## Deemed Provisions – CI 67 Matters to be considered by local Government

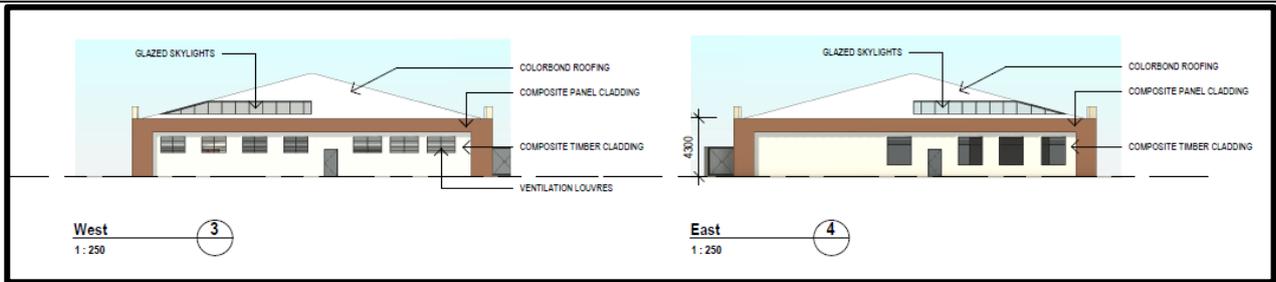
The proposed elevations of the 'Service Station' are depicted below:

The building, as relocated, would be set back 42.3m from the existing eastern lot boundary (Kargotich Road) and approximately 126m from the existing northern lot boundary (Thomas Road). The design incorporates a hipped roof and verandah to reflect the form of a rural building. The building also features a brick feature wall, utilising materials consistent with the Shire’s rural character.

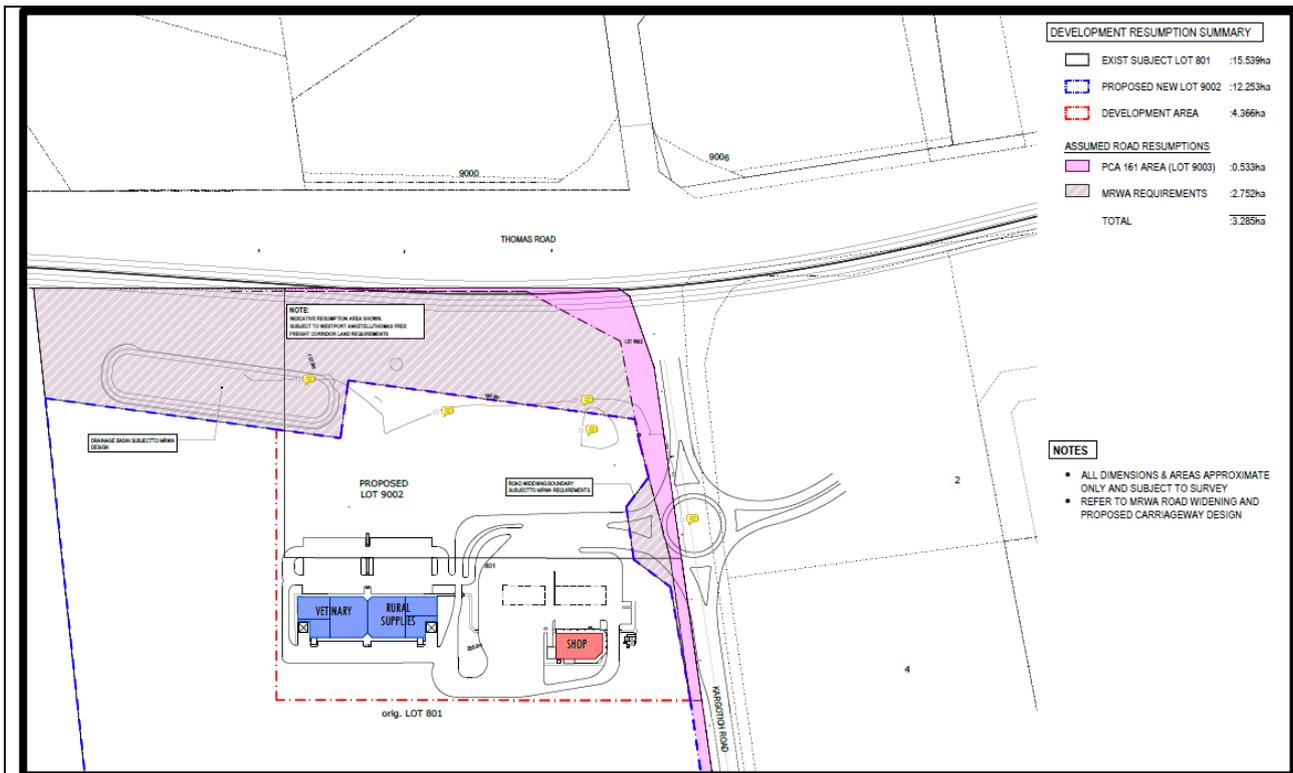
As part of the Westport Project which seeks to improve freight linkages from Kwinana, concept plans for the project have identified a grade separated interchange is the most likely intersection configuration that will be required at the intersection of Thomas Road and Kargotich Road. The concept of this is depicted below:

The grade separated intersection would allow uninterrupted flow of freight vehicles whilst maintaining local road connections supporting the growth of industry. This will require reconsideration of the land requirements identified for the PCA. Whilst the revision of the PCA is not yet formalised, in consultation with the WAPC and MRWA the applicant has provided a plan depicting the assumed new land required in relation to the development as depicted below:

*Interim Scenario:*

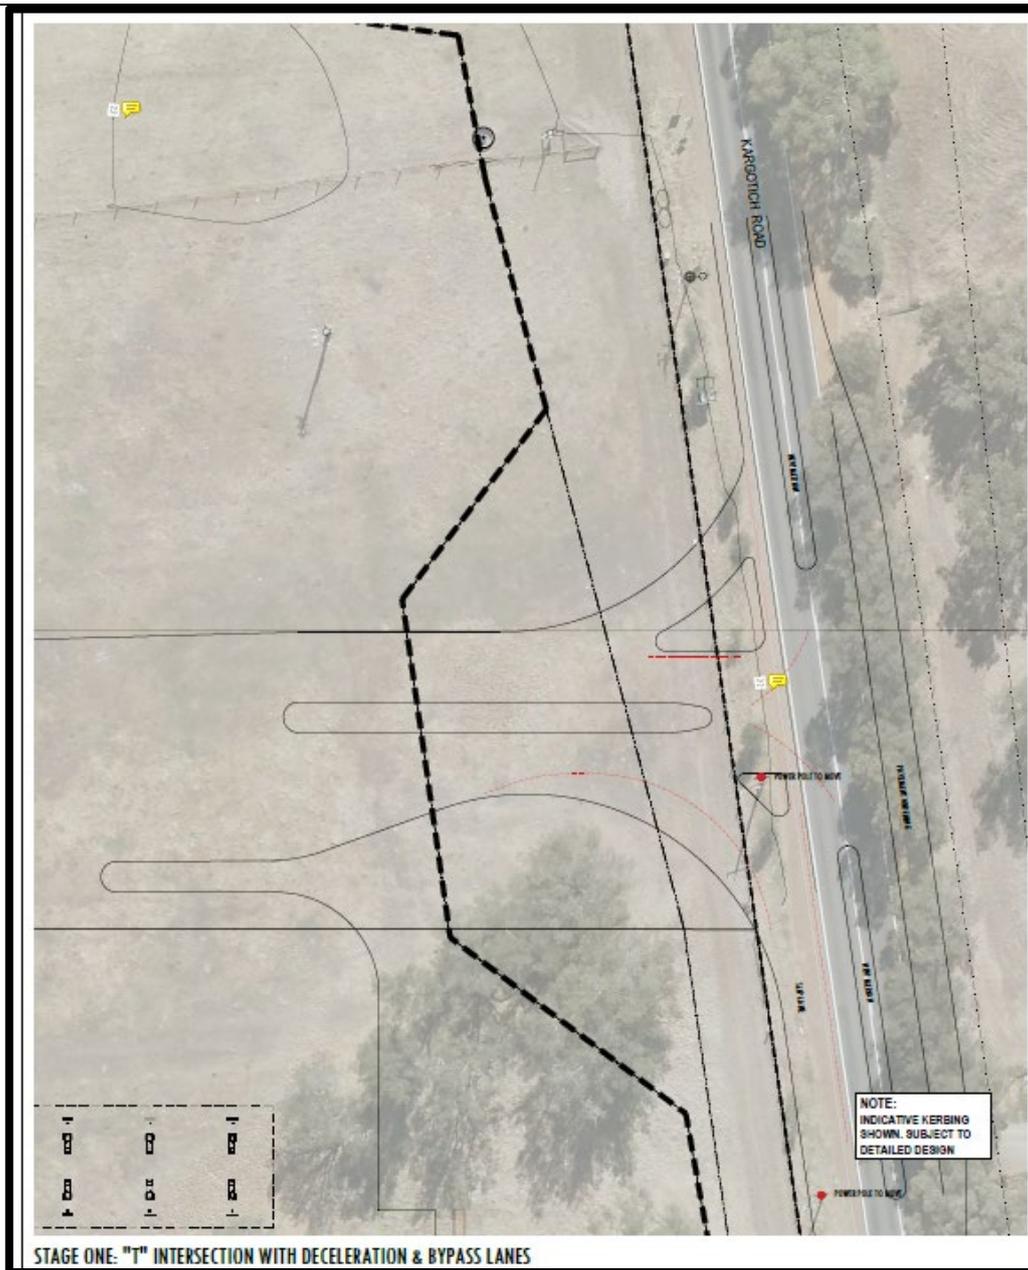
The interim scenario is based around the roundabout being constructed at the intersection of Thomas Road and Kargotich Road and comprises of a 'T' intersection. As part of the upgrades of the roundabout intersection, approach and departure lanes on Thomas Road will be upgraded to two lanes and approach lanes northbound on Kargotich Road (south of the roundabout) will also be upgraded to two lanes. These upgrades will accommodate RAV vehicles for Thomas Road and Kargotich Road and as such allow for the fuel tankers and heavy vehicles associated with the 'service station'.

*Ultimate Scenario:*

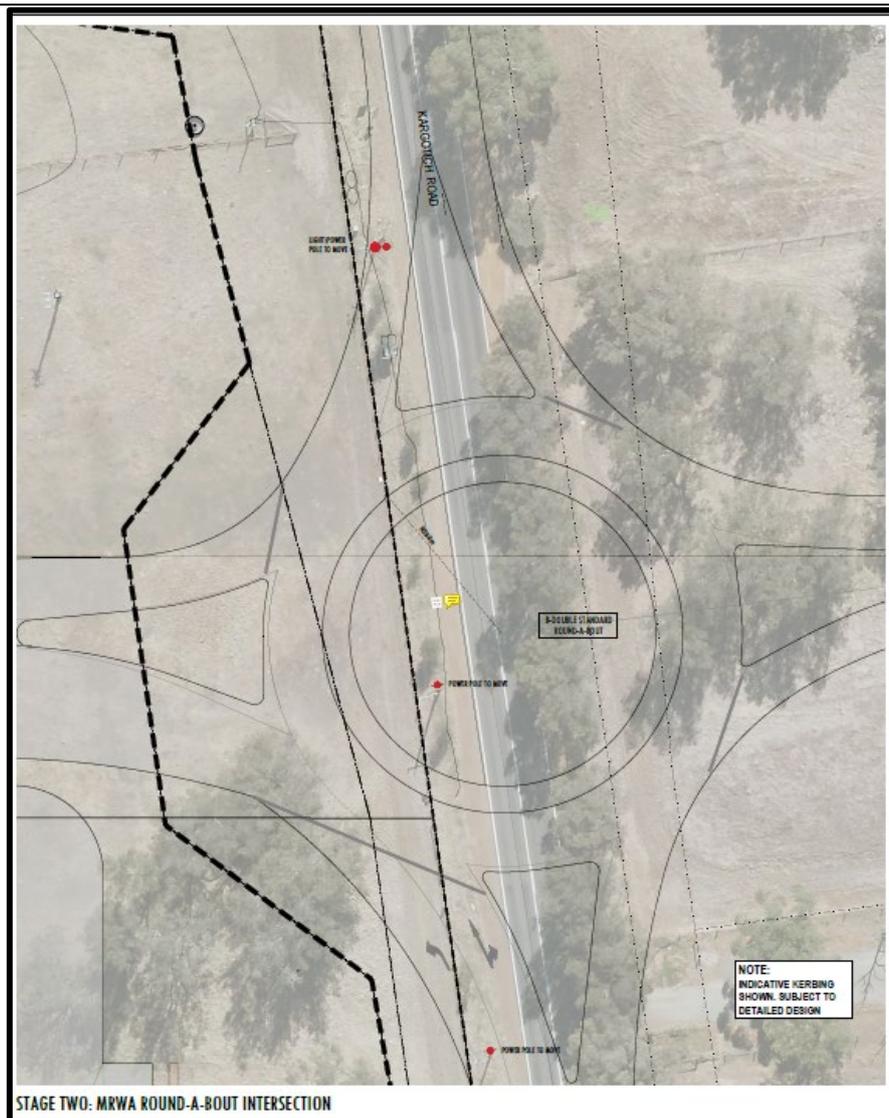
Once the grade separated intersection is constructed, access to the site would be upgraded from a 'T' intersection to a roundabout with the fourth leg of the roundabout being the Thomas Road westbound on and off ramp, as depicted below:

These proposed access arrangements are to the satisfaction of MRWA who has confirmed that the development can occur without compromising the current or future plans for the road network.
